ICC A117.1 Committee Action Report

Proposal list to the 2017 A117.1 for the 2023 edition –
2-24-2022 through 1-19-2023
Chapter 1 to 5

**FIGURE 304.3.2.1.1
T-SHAPED TURNING SPACE
NEW BUILDINGS - OVERLAP**

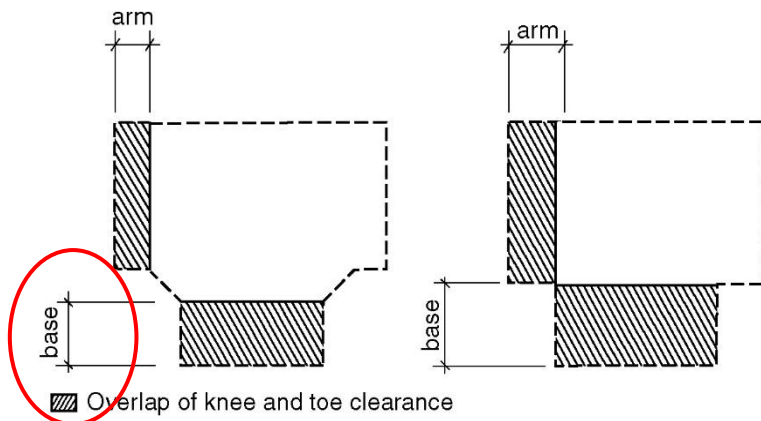
304.3.2.1.1 Overlap. Turning spaces shall be permitted to include knee and toe clearance complying with Section 306 of either the base or one arm. For Option 1, the base or arm is ~~the portion beyond~~ includes the chamfer.

REASON: The purpose of this proposal is to coordinate the overlap allowances for turning spaces. The A117.1 decided not to change the knee and toe clearances between the 2009 and 2017 edition. The turning spaces have increased in size and substantially limited the overlap at the same time. Since the circle and T-turn are to turn 180 degrees, they should be consistent – while now there are substantial differences in all 4 options. With the larger turning space, these proposals will still be a reduction on the total percentage of the turning space permitted under the

Figure 307.3 (B)

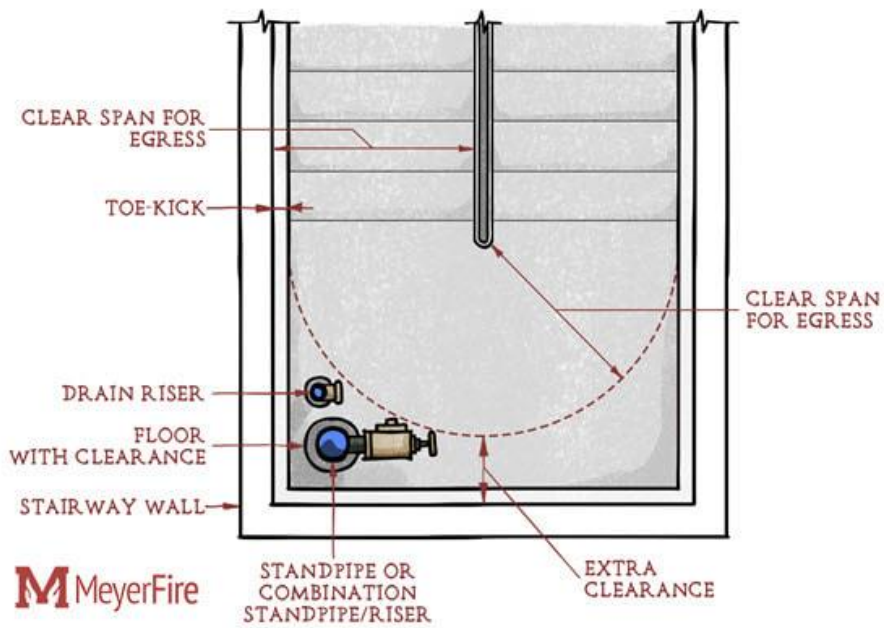
Reason: There is a current issue with standpipes where required in exit stairways. Fire department have to have access to connections, including substantial room for leverage to operate valves. Where designers have chosen cowl detection, access is limited. Where designers have chosen low bars for detection, some code officials have cited them for reducing the landing to below the required depth. **ADA allows for objects on posts to stick out 12" maximum.**

Figure 405.9.2.2 Barrier

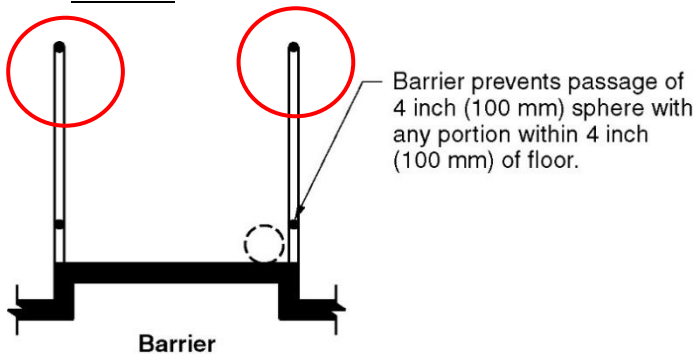
Staff note: Direction is required for changes to Figure 405.9.2.2.

FIGURE 405.9.2.2

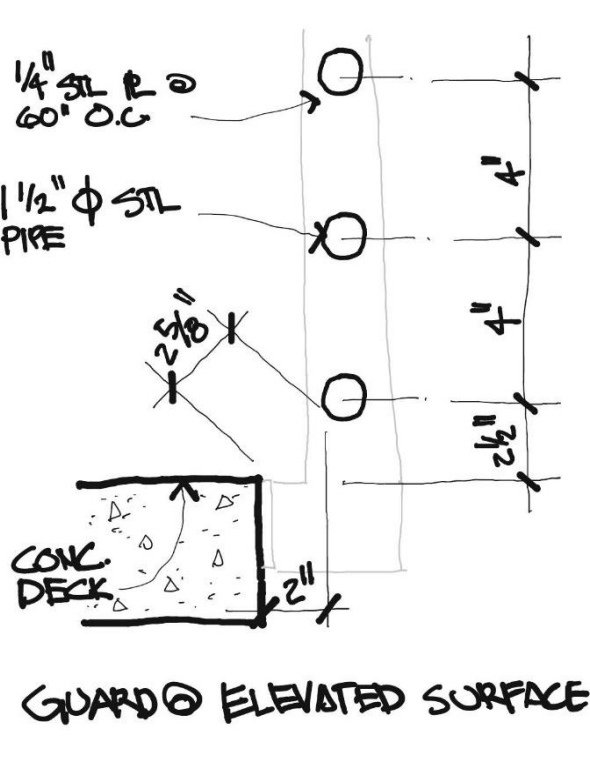
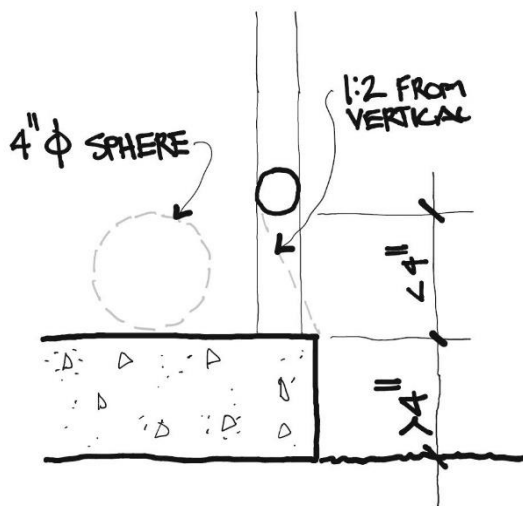
Reason: To clarify some issues that may arise with where the edge protection would be required that would be problematic.

Report for 04-02- 2021		
<i>Committee decision: D</i>	<i>Committee Vote at Meeting: 28-0-3</i>	<i>Committee Vote on Ballot: 40-0-1</i>
REPORT OF HEARING:		
Modification (if any):		
Committee Reason: Adding edge protection at the locations indicated raised concerns about the potential for tripping hazard for non-wheelchair users. Issues with guards should be addressed in the building code since they are not required in ICC A117.1. code. The proposed language is not clear for if this requires a curb or railing; and the extent of where this would be required is not clear.		
PUBLIC COMMENT- FIRST DRAFT:		
Proponent:		
Desired Action:		
Modification:		
Reason:		
<i>Committee decision: AS/AM/D</i>	<i>Committee Vote at Meeting:</i>	<i>Committee Vote on Ballot:</i>
REPORT OF HEARING – FIRST DRAFT		
Modification (if any):		
Committee Reason:		
PUBLIC COMMENT- SECOND DRAFT:		
Proponent:

Figure 404.2.5(A) Two Doors or Gates in a Series - New Buildings

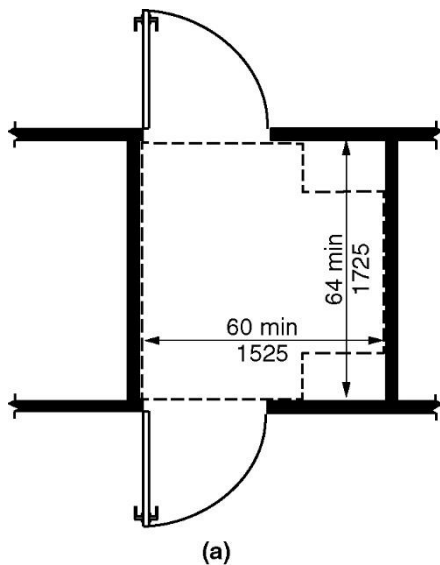
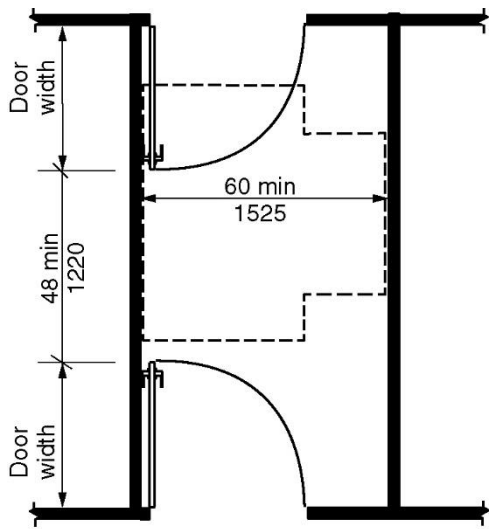
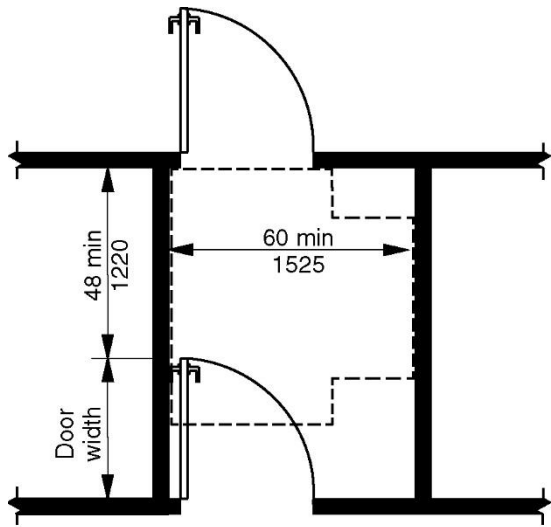
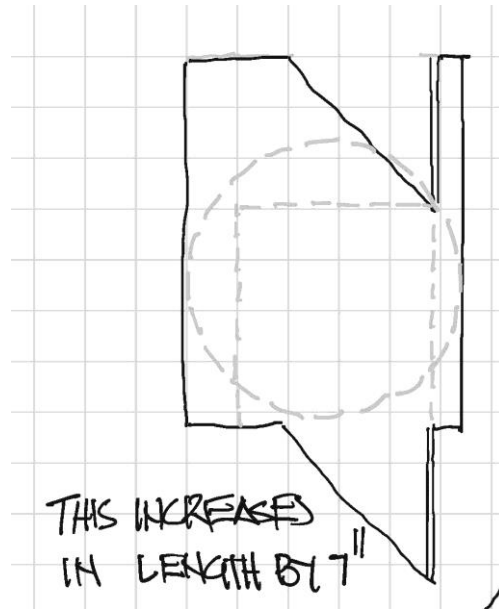
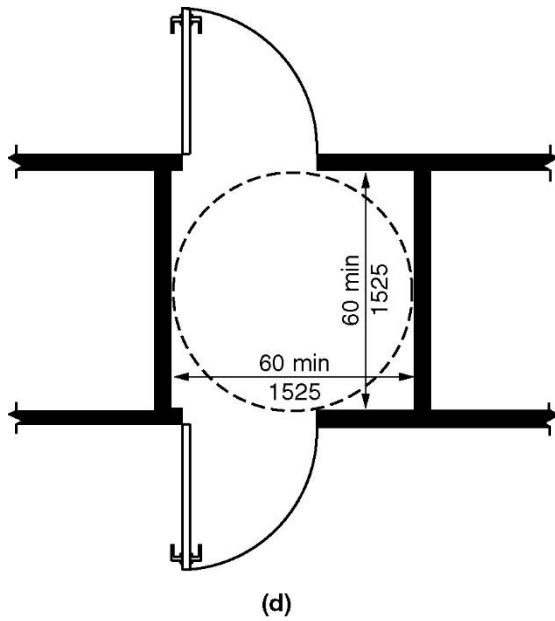
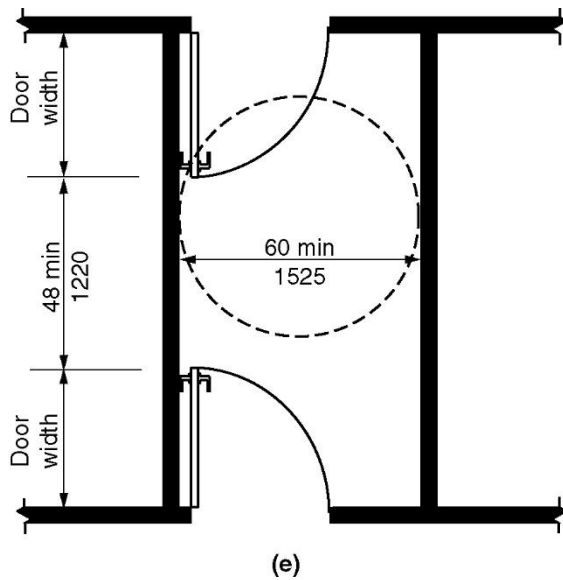
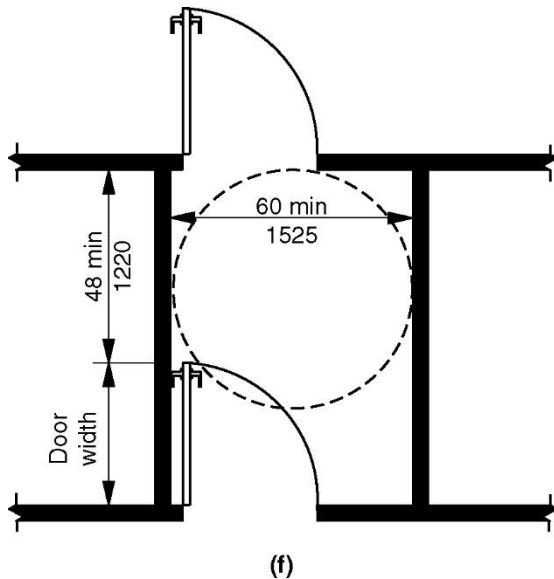
Note: The vestibule would increase by 4" due to the increase in the maneuvering clearance for forward approach. Drawing will all be revised include door maneuvering spaces.

Staff note: If this proposal is accepted, the committee will need to provide direction on changes to Figures 404.2.5(A) through 404.2.5(F).

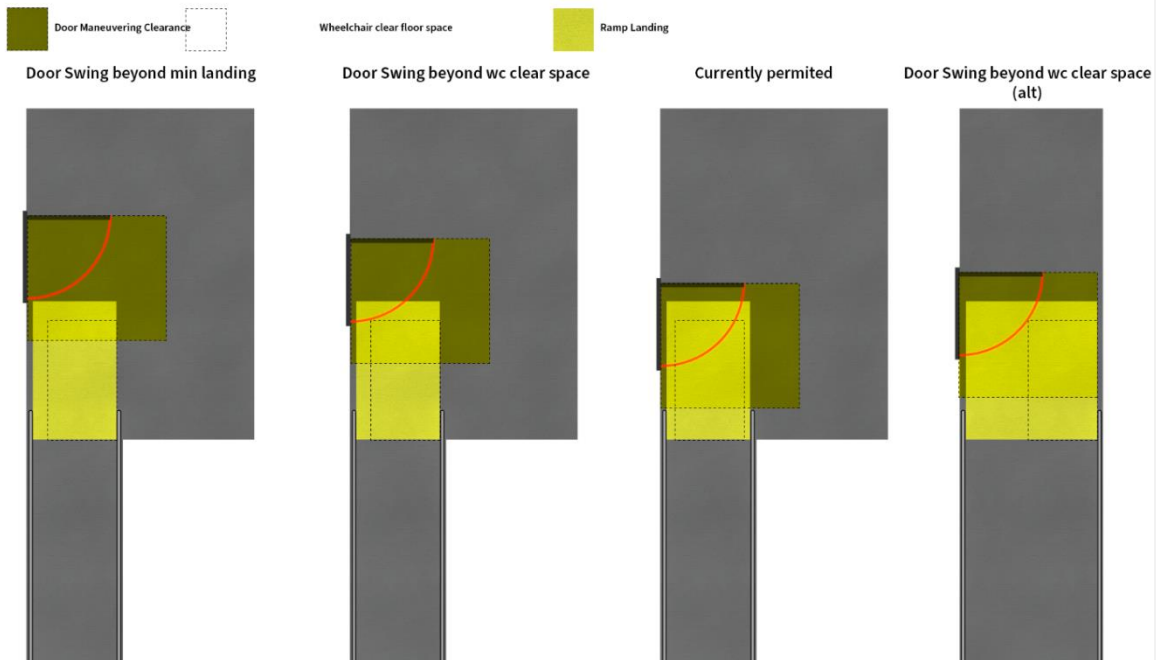
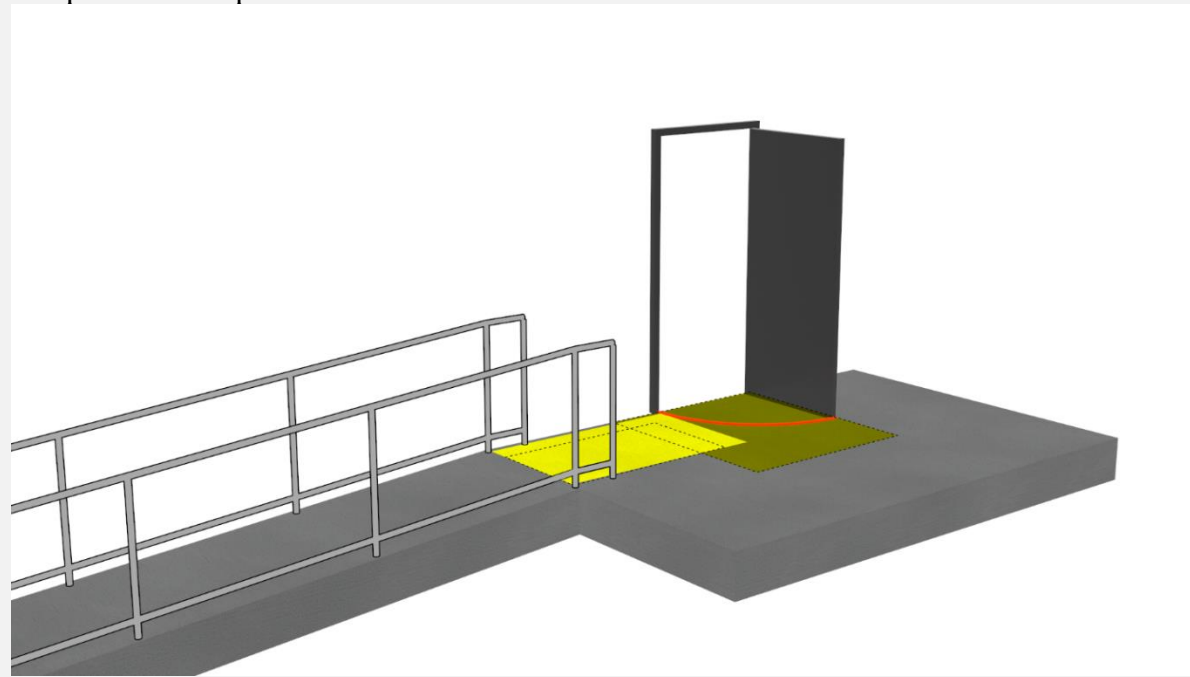
Reason: Potential Solutions:

Report for 04-21– 2021		
Committee decision: <i>D</i>	Committee Vote at Meeting: 16-5-1	Committee Vote on Ballot: 37-3-1
REPORT OF HEARING:		
Modification (if any):		
Committee Reason: While this proposal is appropriate for minimum size ramps and landings, there were a couple of concerns raised that need additional clarification. The committee agrees with the figures in the A117.1 commentary for Section 405.7.5 that illustrated the concerns for persons moving up a ramp to a landing with a door. However, if a ramp is very large, such as in a sports stadium, the doors swinging over the required ramp landing would most likely not be a conflict. If a ramp is for means of egress only, the door could swing over a ramp landing in the direction of travel.		
PUBLIC COMMENT- FIRST DRAFT:		
Proponent: Scott Windley		
Desired Action: Negative with Comment		
Modification:		
Replace with the following:

**FIGURE 406.2(A)
PERPENDICULAR CURB RAMP**

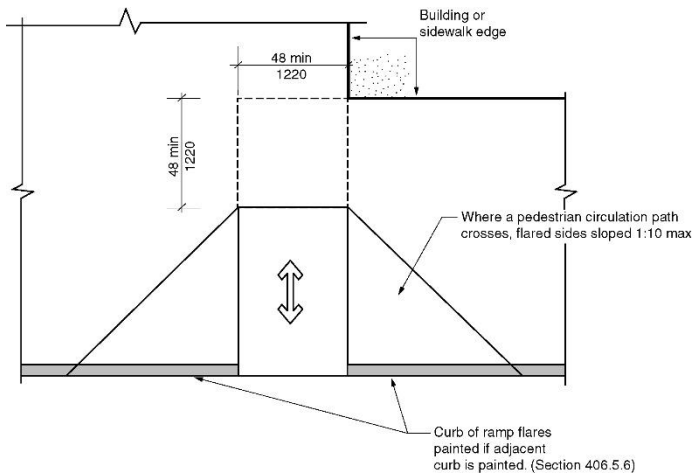
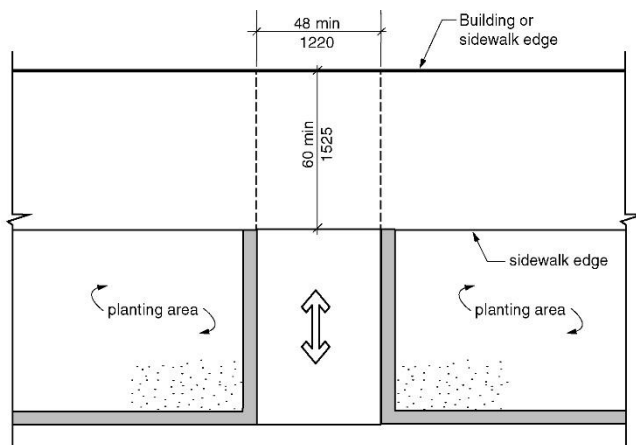
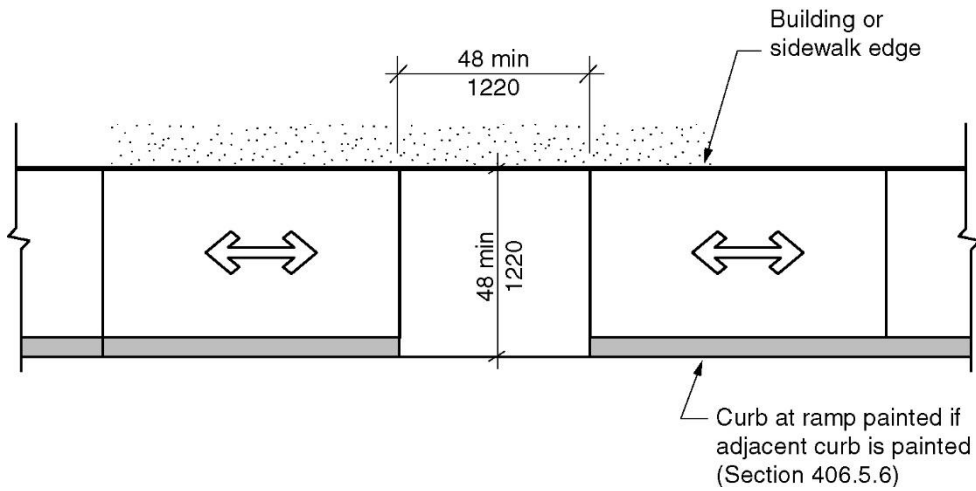
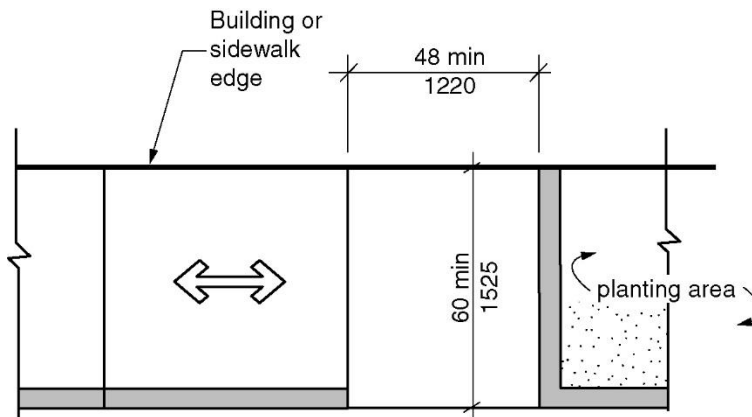
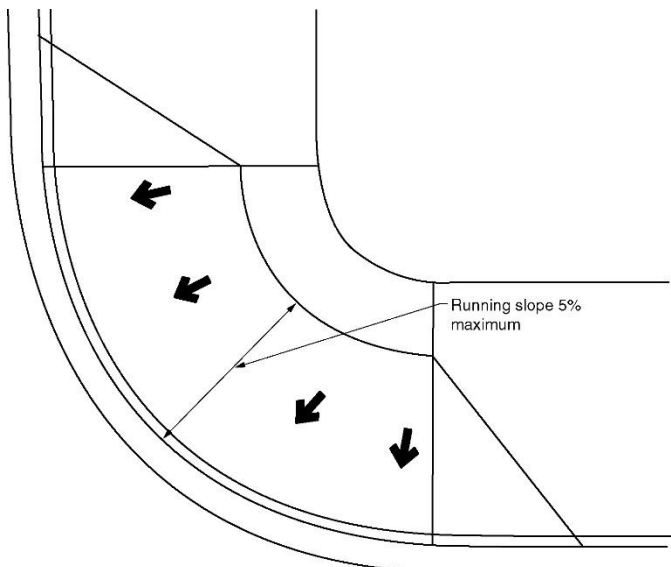
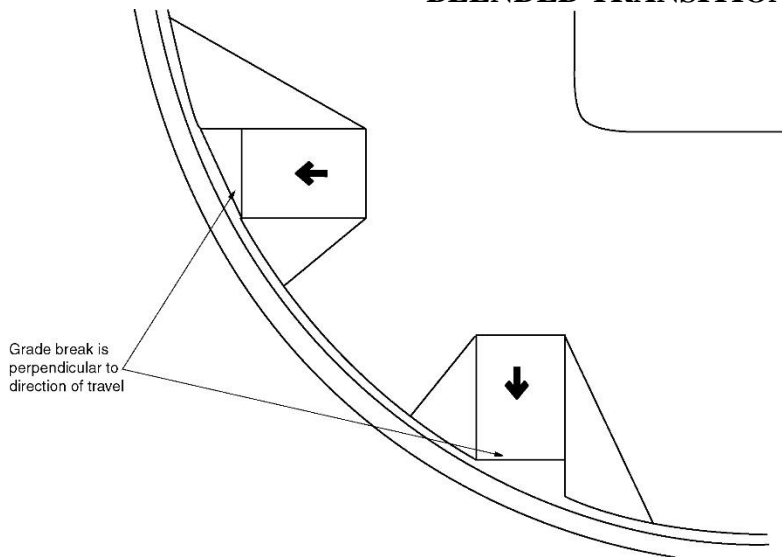
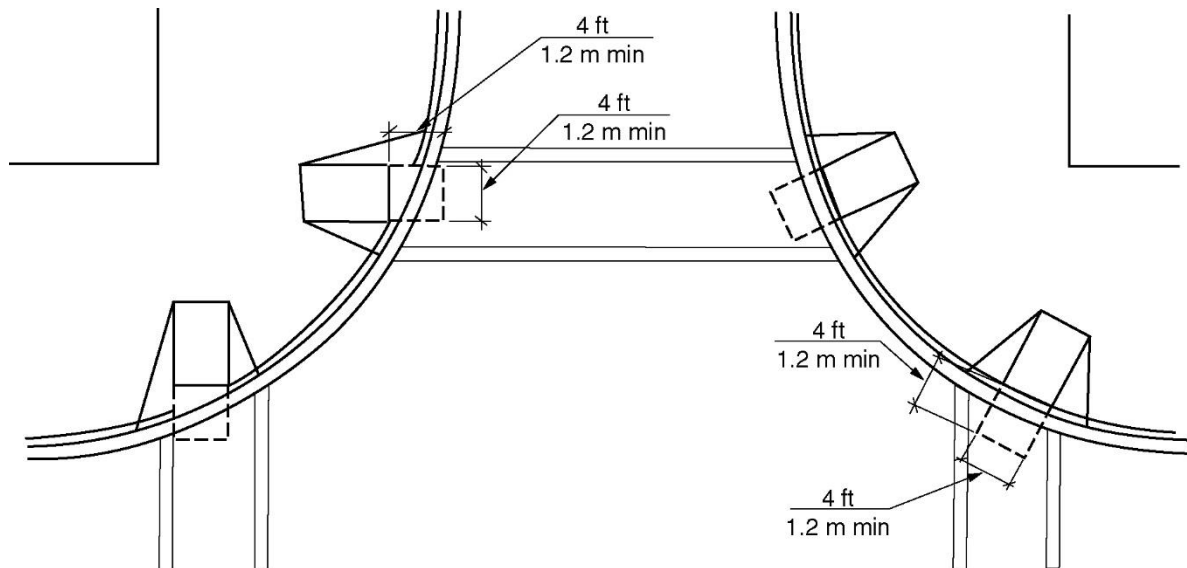
Note: These figures should all show detectable warnings.

REASON: Curb ramps are not complete without detectable warnings. While there is a section showing detectable warnings on curb ramps in some detail, they should not be omitted here. It implies that they are not required. Wherever curb ramps are depicted, unless they are not required to have detectable warnings, as in Figure 502.9.1, the detectable warning should be

Committee Reason: The first modification was approved because the committee felt that it was important to clarify that detectable warnings were only required in limited situations, thus the addition of the note in each drawing. The 2nd modification was approved to remove the original proposal’s suggestion to show the detectable warning on each curb cut. The committee felt that many people just looked at the pictures rather than the text, so showing the detectable warnings would be misleading. The final proposal was approved because the committee felt the note would address the concern for where detectable warnings would be required and at the same time not seem to require detectable warnings at all locations – especially at locations where detectable warnings would provide misinformation – like at access aisles or into parking lots. PROWAG requires detectable warnings at street crossings.

**FIGURE 502.9.1
WIDE SIDEWALKS**

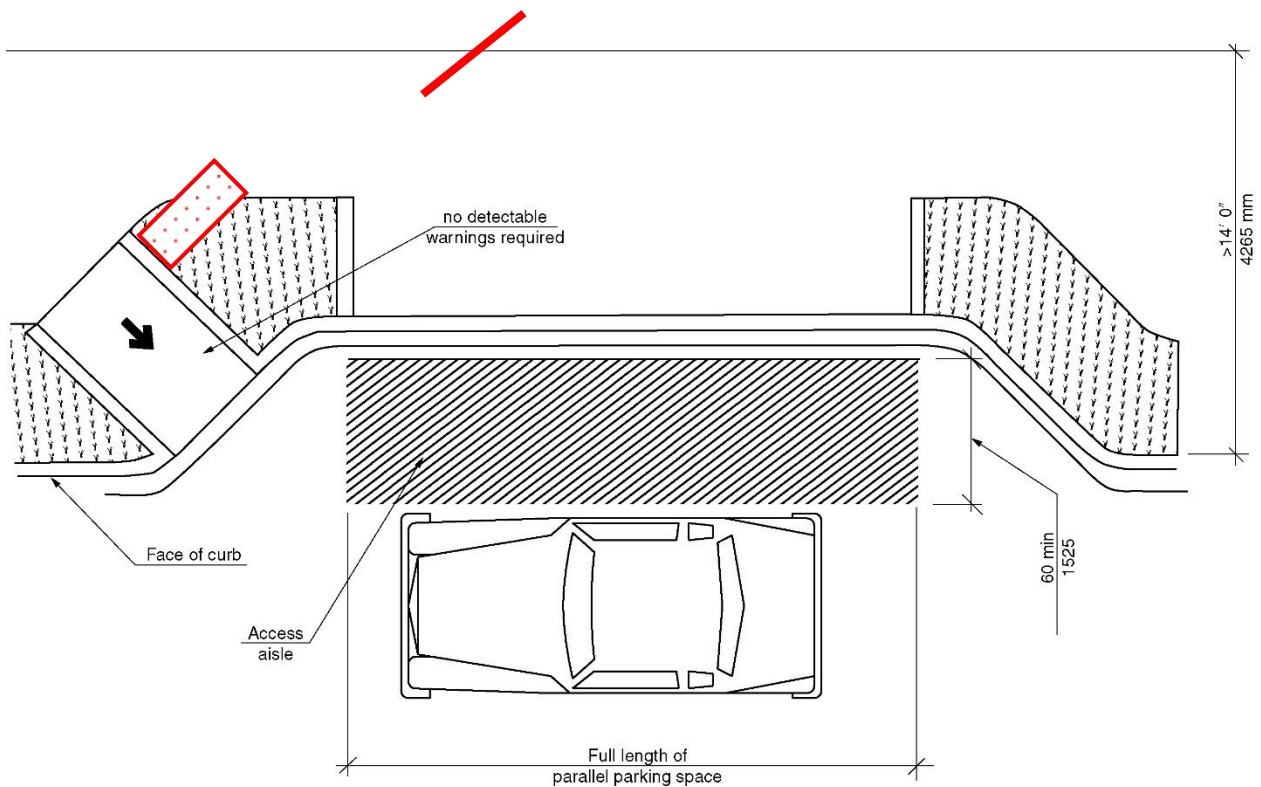
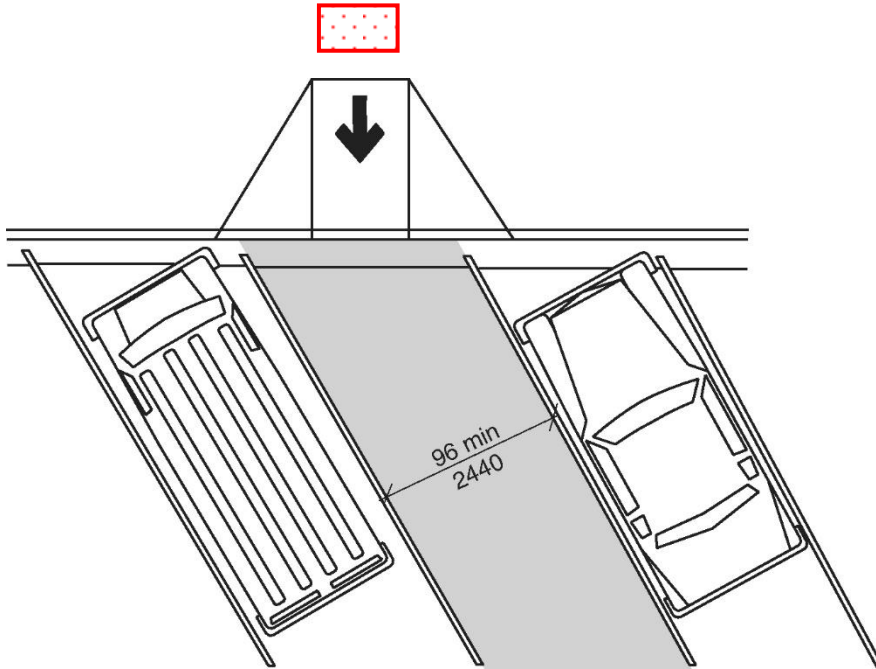
Note: The curb ramp in this figure should show detectable warnings.

REASON: Curb ramps are not complete without detectable warnings. While there is a section showing detectable warnings on curb ramps in some detail, they should not be omitted here. It implies that they are not required. Wherever curb ramps are depicted, unless they are not required to have detectable warnings, as in Figure 502.9.1, the detectable warning should be included. Figure 502.9.1.2 correctly includes the detectable warning, even though it is in Section 502 Parking Spaces.
